AGENDA ITEM E. NEW BUSINESS

ITEM 9 – KALIFORNSKY MEADOWS 2021 ADDITION

KPB File No.	2021-051
Plat Committee Meeting:	September 13, 2021
Applicant / Owner:	RCMS, Inc. of Kenai, Alaska
Surveyor:	John Segesser / Segesser Surveys
General Location:	Kalifornsky / Kalifornsky APC

STAFF REPORT

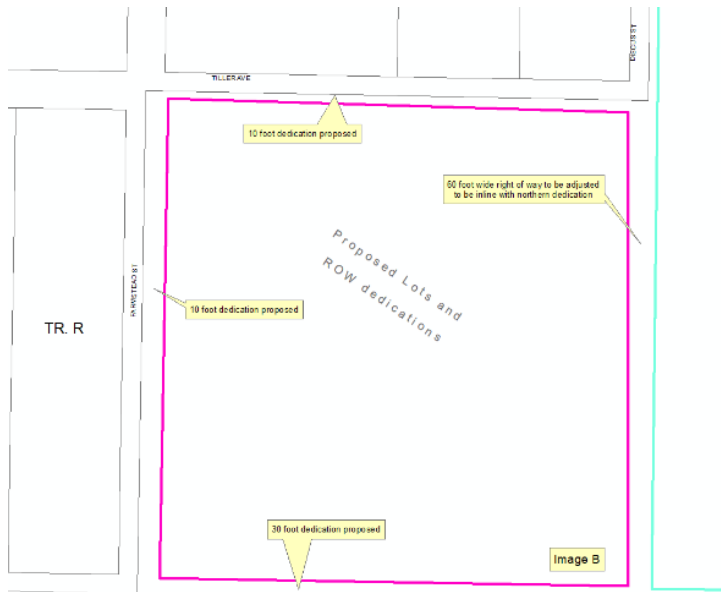
The east 80 acres will be required to be designated as a parcel of land. **Staff recommends the east 80 acres be designated as a separate Tract similar to Image A.**

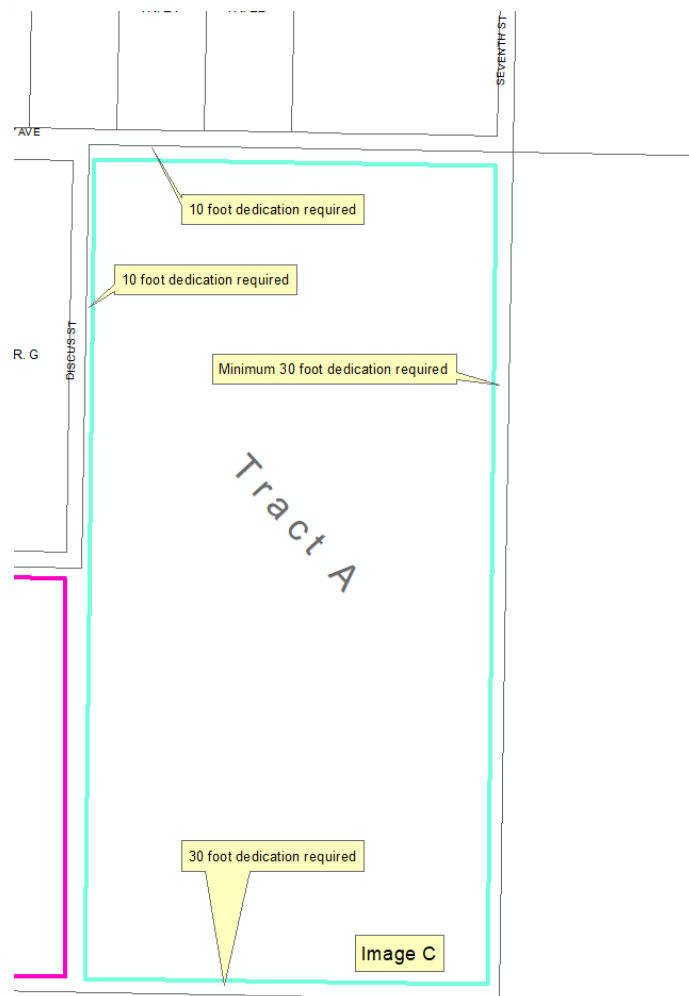
Tiller Avenue and Farmstead Street are currently 50 foot wide dedications. Sheet 2 indicates that 10 foot dedications are proposed and a 30 foot dedication along the south that coincides with a 50 foot section line easement (Image B).

A 60 foot wide dedication is proposed to provide a continuation of Discus Street. The design proposed shows a 10 foot offset from the northern dedication. This appears to be occurring due to unit locations. As discussed previously, this plat cannot change any unit design. **Staff recommends the right of way dedication for Discus Street be 60 feet wide and align with the current dedication of Discus Street.** (Image B).
